From: Corey York
Sent: Wednesday, August 01, 2012 12:23 PM
To: Manager Department
Cc: Police Department; Fire Department; JD Head; Highway Department; 'Scott Hayes'
Subject: FW: Proposed Street Parking Spaces on Spruce Street
Attachments: 2011-03-25 - Site Plan.JPG; WAVE-SITEPLANS-3.jpg; PHOTO A - Spruce St at Mass Ave - Proposed Centerline.pdf; PHOTO B - Spruce St at St #5-9 - Proposed Centerline.pdf; PHOTO C - Spruce St at St #11 - Proposed Centerline.pdf; PHOTO D - Spruce St at Arlington - Proposed Centerline.pdf; PHOTO E - Arlington St at Spruce.pdf; PHOTO F - Windsor Ave by Mass Ave.pdf; PHOTO G - Windsor Ave by Pearl St.pdf; AERIAL - Locus.pdf; Spruce Street - AERIAL LOCUS - proposed centerline.pdf; Traffic Rules and Orders - Parking - Spruce Street (west side) - 2012 - Amendment.pdf; Traffic Rules and Orders - Parking - Spruce Street _east side_ - 2012 - Amendment.pdf

"SPRUCE CORNER"
ARLINGTON STREET & SPRUCE STREET
WEST ACTON, MASSACHUSETTS

SITE DEVELOPMENT PLAN
SHEET 03 OF 12

WAVE
SITE PLAN
ACTON, MASSACHUSETTS

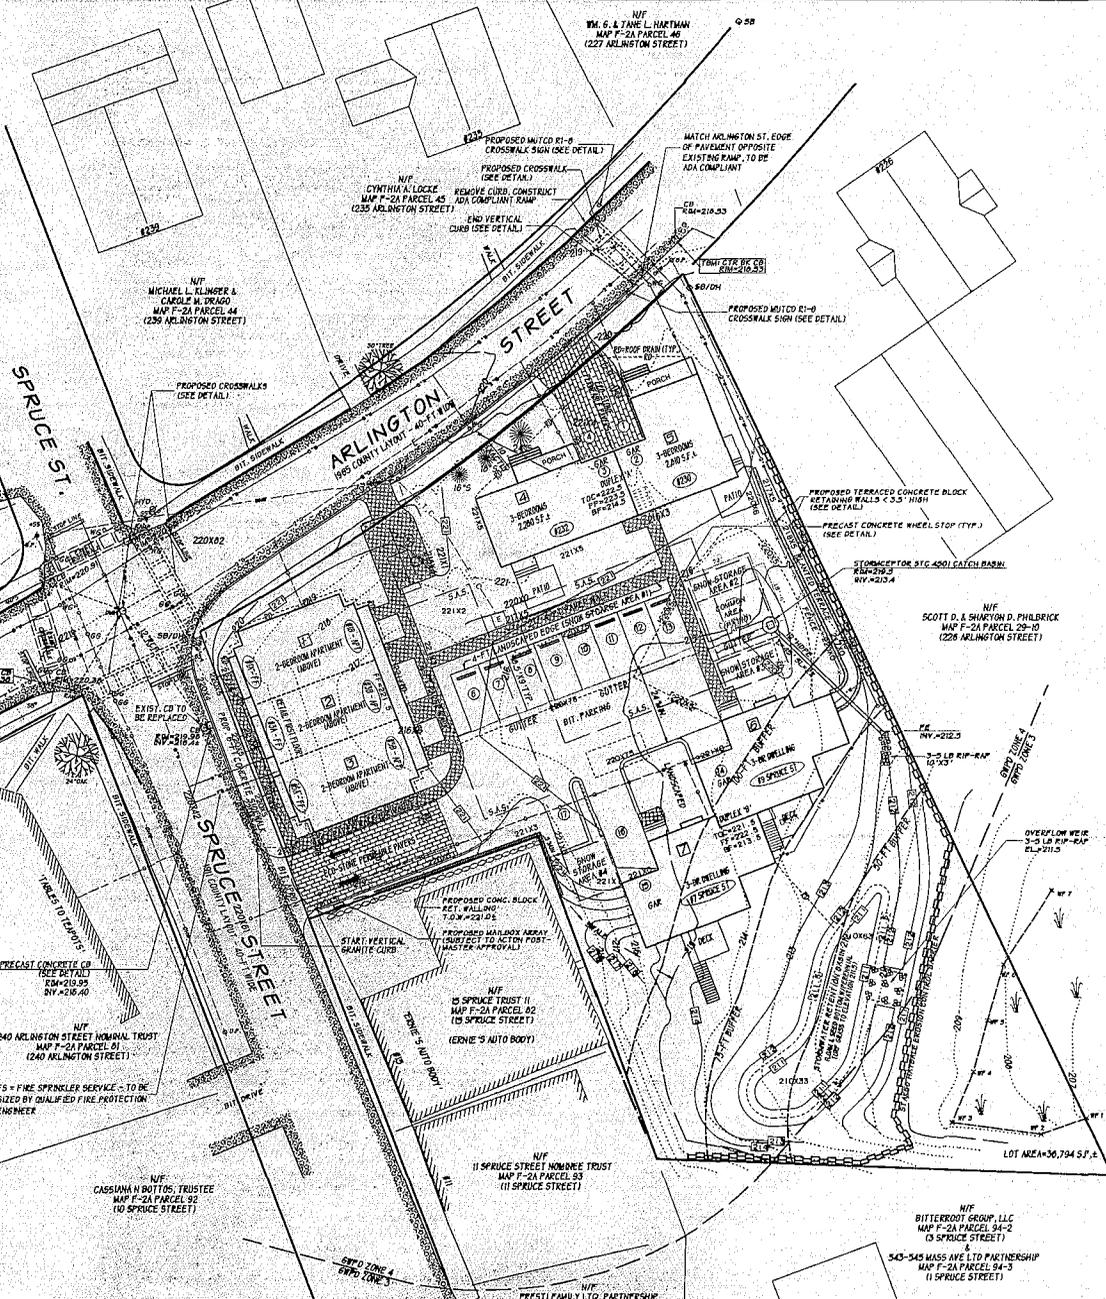
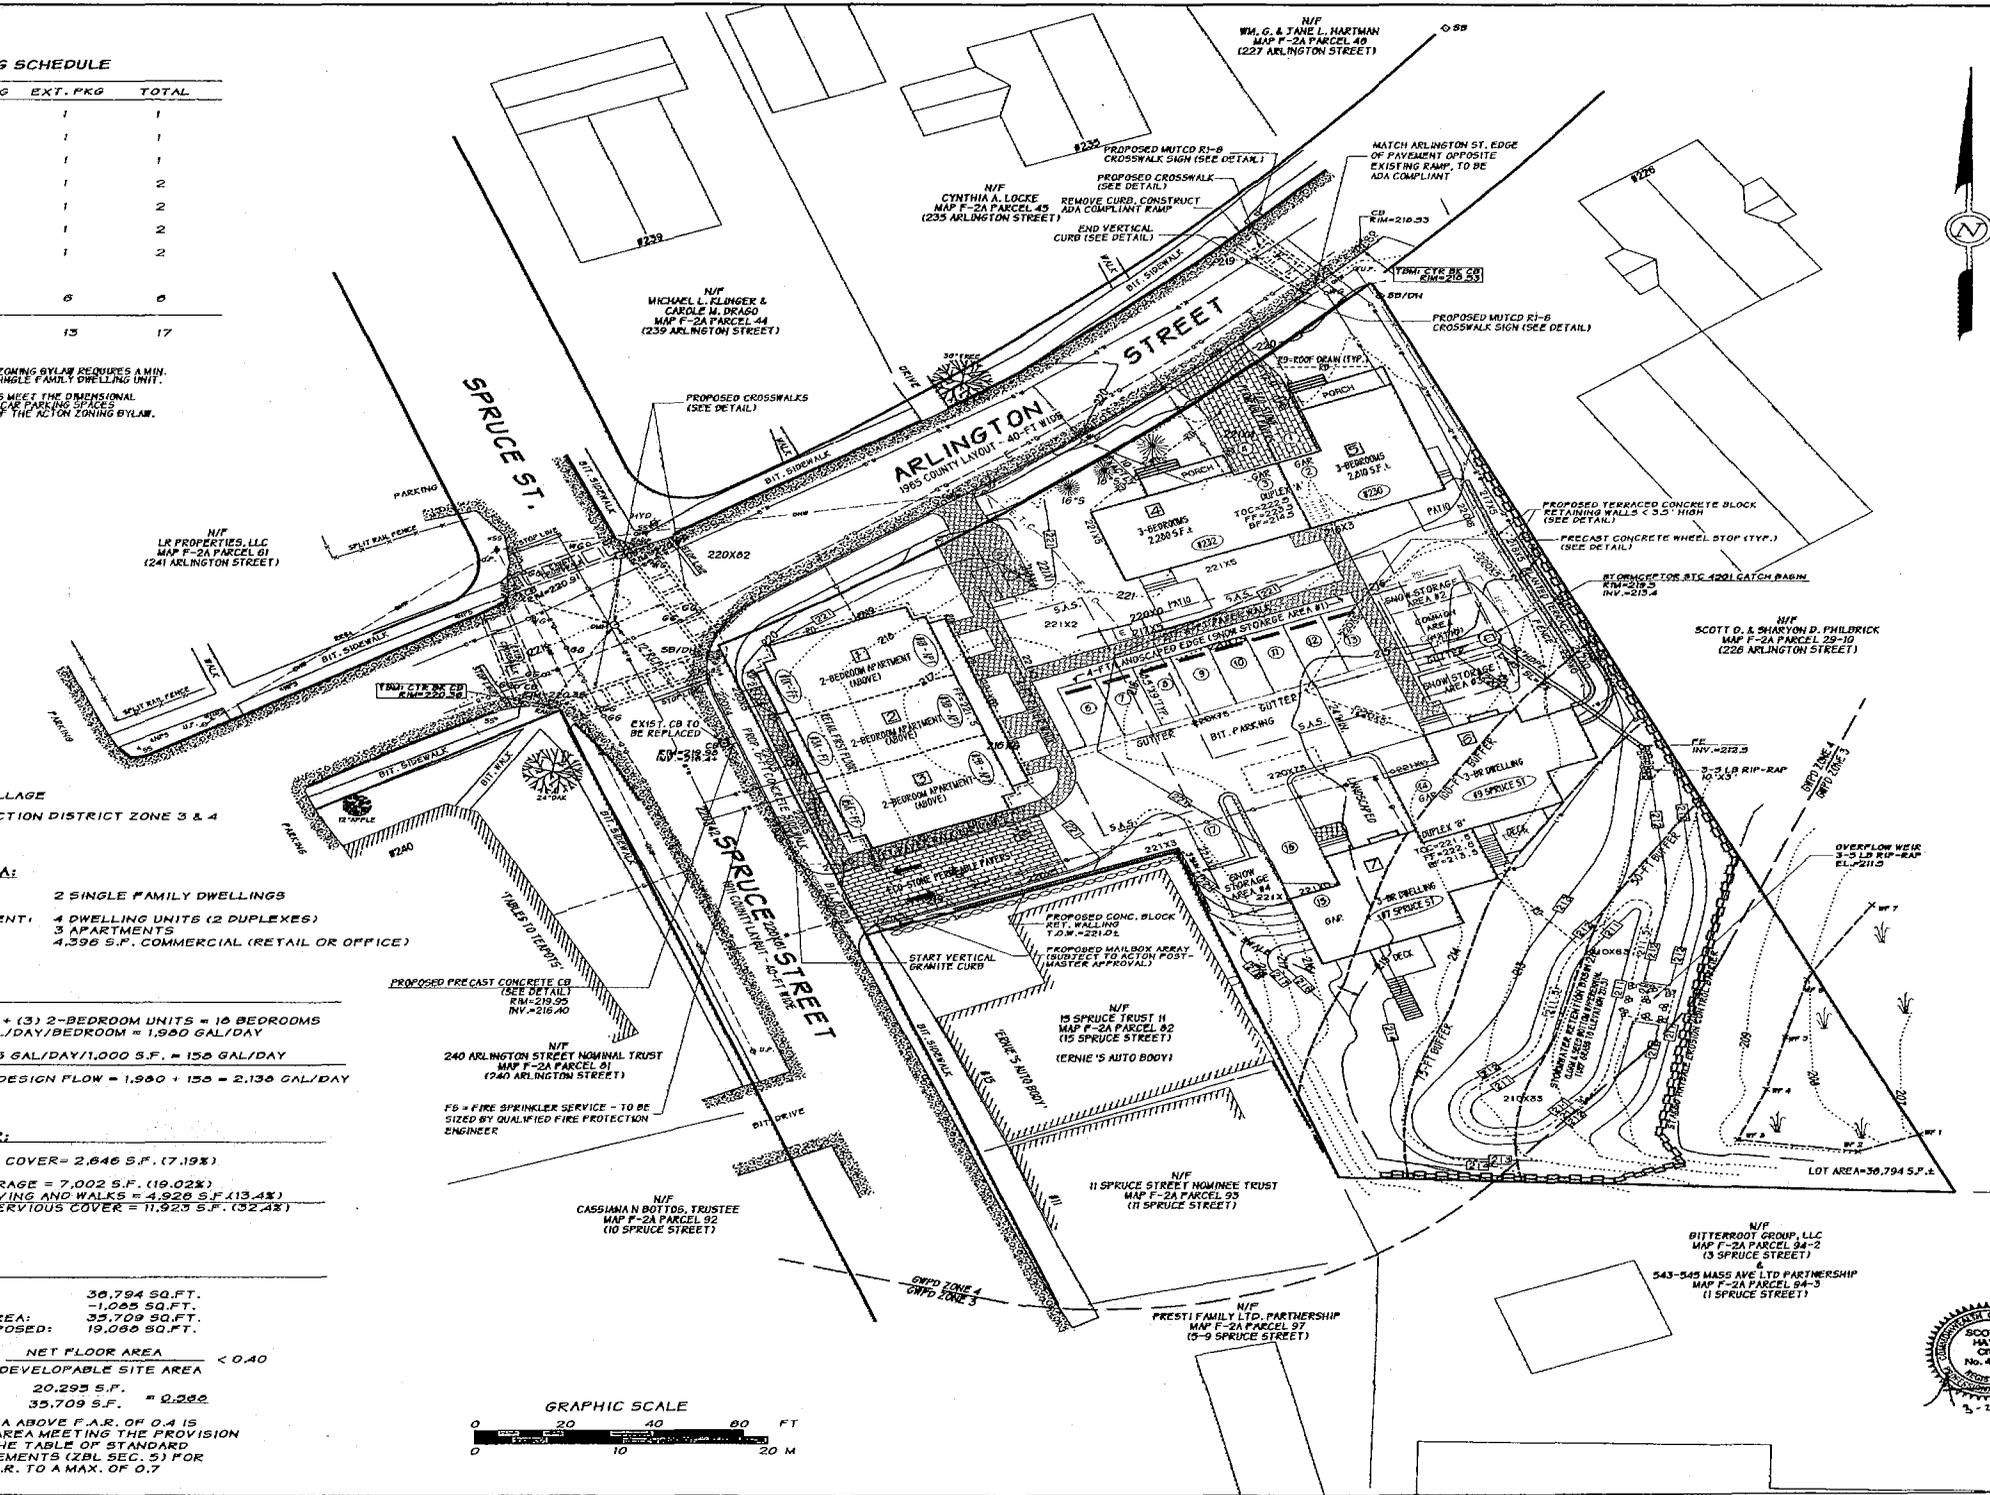
I’ve attached Site Plans for this development at the intersection of Spruce and Arlington (Spruce Corner) and the WAVE Project at the intersection of Spruce Street and Mass Ave. The plans show the edge of the ROW for Spruce Street at both intersections to be within the sidewalk. The edge of the Spruce Street ROW then shifts to edge and/or slightly within the road pavement at about 11 Spruce Street (Ernie’s Auto Body & the computer repair facility).

- The road pavement for Spruce Street will be no less than 24 feet wide.
- The three (3) proposed parking spaces will be 22 feet in length by 8 feet wide. This conforms to the parking standards established in the Zoning Bylaw.
- The proposed parking will have a 20 foot minimum offset from the paved intersection rounding at Arlington Street. This will conform to the TR&Os general parking prohibition at/near intersections.
- These spaces will remain open to the public
- The new parking spaces are shown to remain entirely within the Spruce Street layout

The relocated granite curbing should not impact the existing 5 foot wide concrete sidewalk along Spruce Street.

The typical cross-section for the bituminous concrete should, at a minimum, comply with the standards set forth in the Subdivision Rules and Regulations for a street.

The granite curbing should be installed in the same manner as approved on their Spruce Corner development plans.

The applicant should be responsible for the pavement markings to delineate the three (3) parking spaces.
